**PUD &  
SUBDIVISION STAFF REPORT**

**Date: July 7, 2005**

**DEVELOPMENT NAME**      D'Iberville Town Homes

**CONTEMPLATED USE**      Amend a previously approved planned unit development to allow reduced lot size, widths, reduced building setbacks, increased site coverage, and on-street shared parking for a single-family residential town home subdivision.

# SITE PLAN

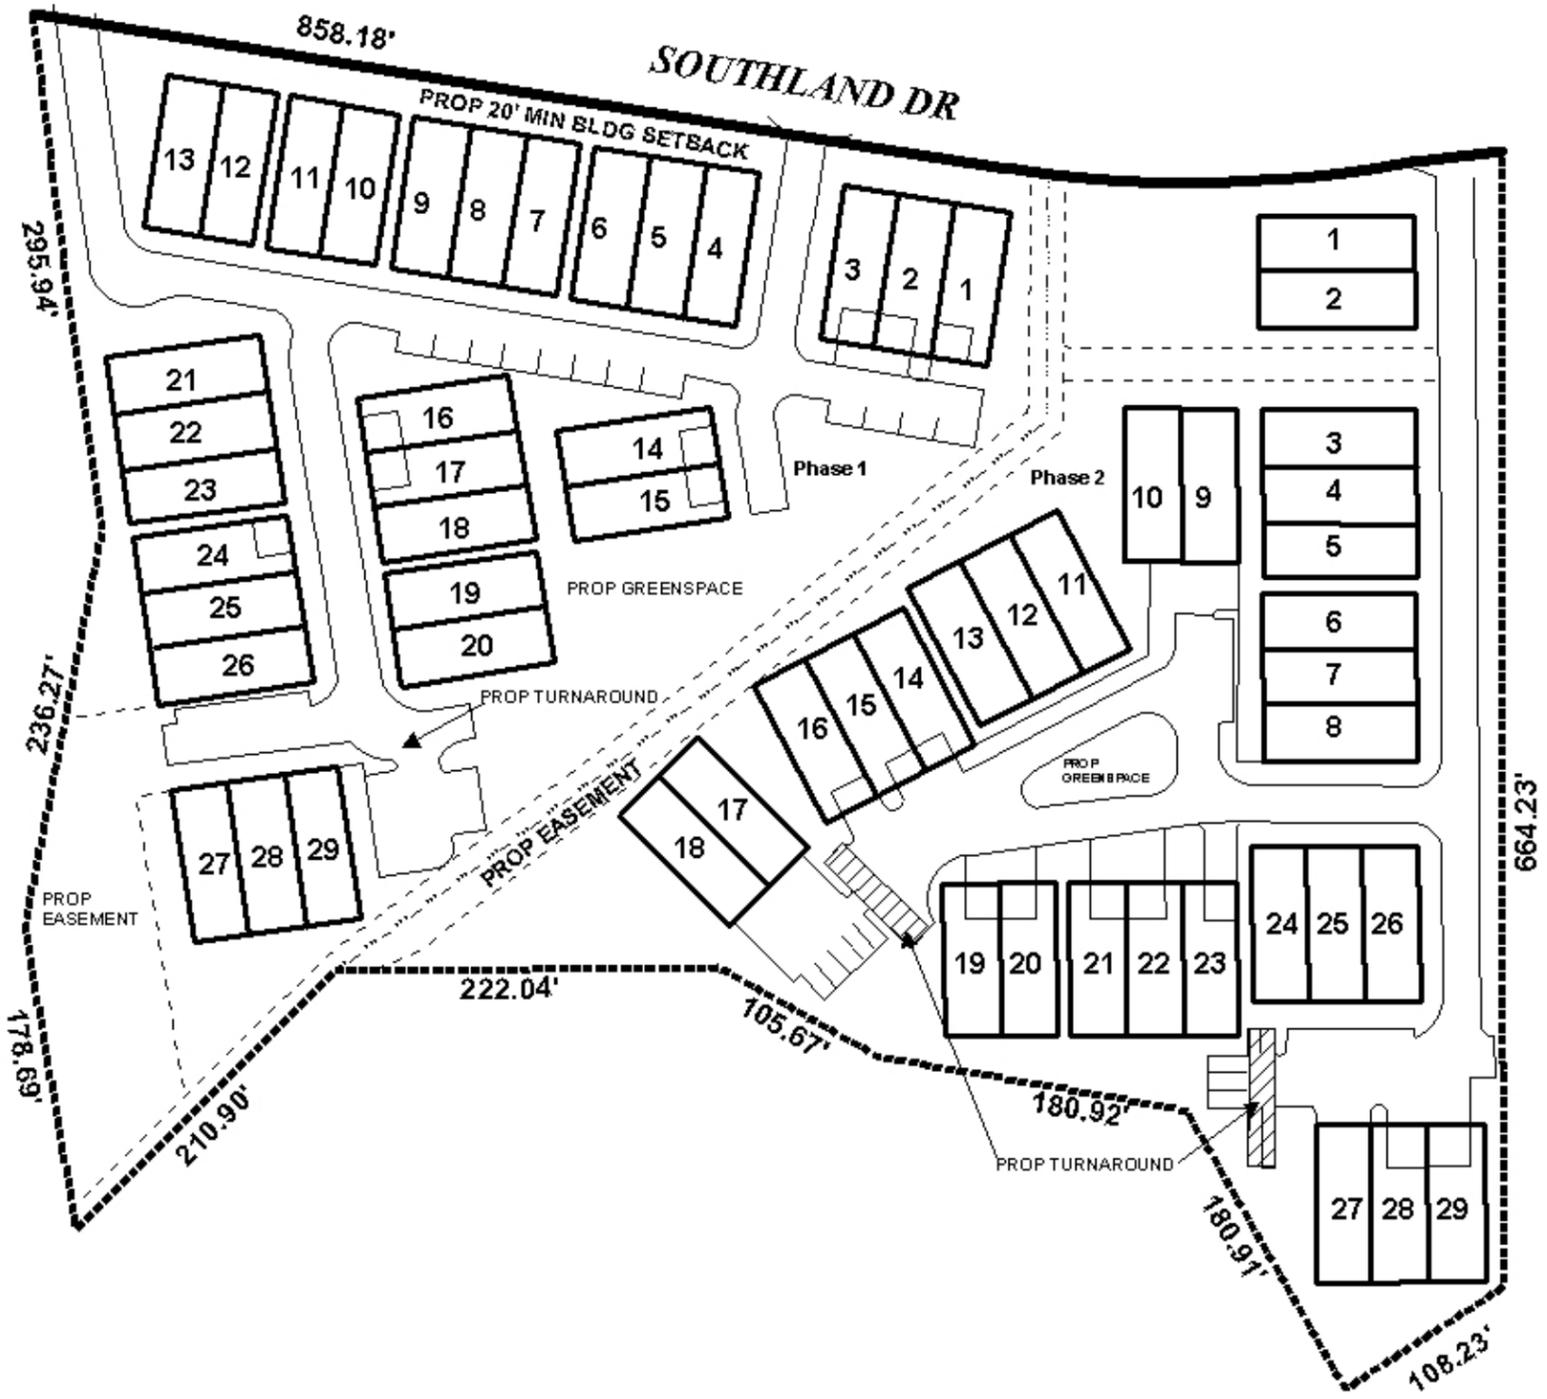
Roadway layout appears not to be City standard. Some cul-de-sacs do not have adequate ROW specified and curbing stated (“role-back”) is not City standard. If streets are to be dedicated to and maintained by the COM, they must be constructed to City of Mobile standards.

Driveway number, size, location, and design to be approved by Traffic Engineering and conform to AASHTO standards. Head in parking that requires backing into the travel way is not allowed. Although right-of-way widths are shown, actual street widths are not given on the drawing and in some instances are not shown. Without this information, it cannot be determined if the shown turnarounds are adequate.

*Revised Traffic Engineering Comments: Driveway number, size, location, and design to be approved by Traffic Engineering and conform to AASHTO standards. Traffic Engineering would prefer that the proposed turnaround be changed to standard cul-de-sacs. A standard cul-de-sac is easily recognized by drivers and will avoid any potential confusion. The extra guest parking at the end of streets (non parallel) should be accommodated in standard parking lot layouts.*

*Roadway layout appears not to be City standard. Some cul-de-sacs do not have adequate ROW specified and curbing stated ("role-back") is not City standard. If streets are to be dedicated to and maintained by the COM, they must be constructed to City of Mobile standards.*

*Site has been cleared without benefit of permit. Please provide appropriate erosion control measures.*

*Comments:* *The applicant has submitted a revised site plan that addresses some of the concerns referenced in the original staff report and comments from other departments, such as better delineation of the parallel parking along the proposed streets and dimensioning of the proposed street improvements, exclusive of the proposed parallel parking (22' clear). The plan also proposes "hammerhead" type turnarounds in several locations to allow for maneuvering of fire trucks and other emergency vehicles. These turnarounds replace previously proposed cul de sacs and eliminate some of the parking that backs into the right-of-way, but not all. Additionally, based upon discussion with Fire Department personnel, there appears to be some question with regard to the functionality of the apparatus turnaround located on the Southeast portion of the site.*

*Revised Comments from Traffic Engineering indicate that the full cul de sacs would be preferable, and that guest parking facilities proposed at the end of turn arounds (not parallel) should be provided in the form of standard parking lots layouts.*

*In concept, the plan could be considered innovative. However, as stated in the original report, PUD approval is site plan specific. Given the concerns regarding parking facility design, Traffic Engineering preference for cul de sacs, and Fire Department concern regarding the functionality of the turnaround in the Southeast portion of the site, approval of the plan as submitted would not be appropriate due to the number of modifications required. Additionally, as stated in the original Engineering Comments, the construction standard stated in the original application is not city standard.*

*The applicant has submitted revisions to the application and site plan, requesting approval for private streets and modifying turn-arounds to satisfy Fire Department needs for apparatus turn arounds.*

*With regard to the request for private streets, the nature of the proposed development could easily be considered innovative, and as such would qualify for consideration as a private street development. Additionally, the change from public streets to private streets addresses most of the concerns with regard to parking that backs into the right-of-way, as well as the issue of cul de sacs vs. hammerhead turn-arounds. Hammerhead turn-arounds are allowed on private streets, subject to approval by the Fire Department.*

*The revisions to the application state that the streets will be constructed to City standards with minor exceptions. These exceptions will be in the areas of the garages, which will be "roll-over" or "mountable" curbs.*

*Subdivision: based on the preceding, it is recommended that the subdivision be considered under the innovate design section of the Subdivision Regulations as a private street subdivision, and granted Tentative Approval subject to the following conditions: 1) compliance with Section VIII.E.2 for private streets (minimum standards, maintenance, etc); 2) full compliance with Engineering Department Standards (Must comply with all stormwater and flood control ordinances. Any work performed in the right of way will require a right of way permit. Engineering will require a drainage easement be dedicated for maintenance of any existing stormwater drainage system located on the property that handles water discharged from a public rights-of-way. The width of the easement is dependant upon the width of the existing drainage-way from top of bank to top of bank plus approximately 10 feet on one side for access purposes. Engineering recommends requiring a minimum of a 25 feet stream bank buffer (from the top of the bank) to protect the highly sensitive Campground Branch stream. The buffer should be left vegetated. A Hold Harmless agreement will be required for any stormwater discharge onto an adjacent property owner if the discharge has been increased or concentrated); 3) all areas not designated as lots be designated as Common Area, and the placement of a note on the final plat stating that maintenance of all common areas and detention facilities shall be the responsibility of the property owners; and 4) design of apparatus turn-arounds to be approved by the Fire Department.*
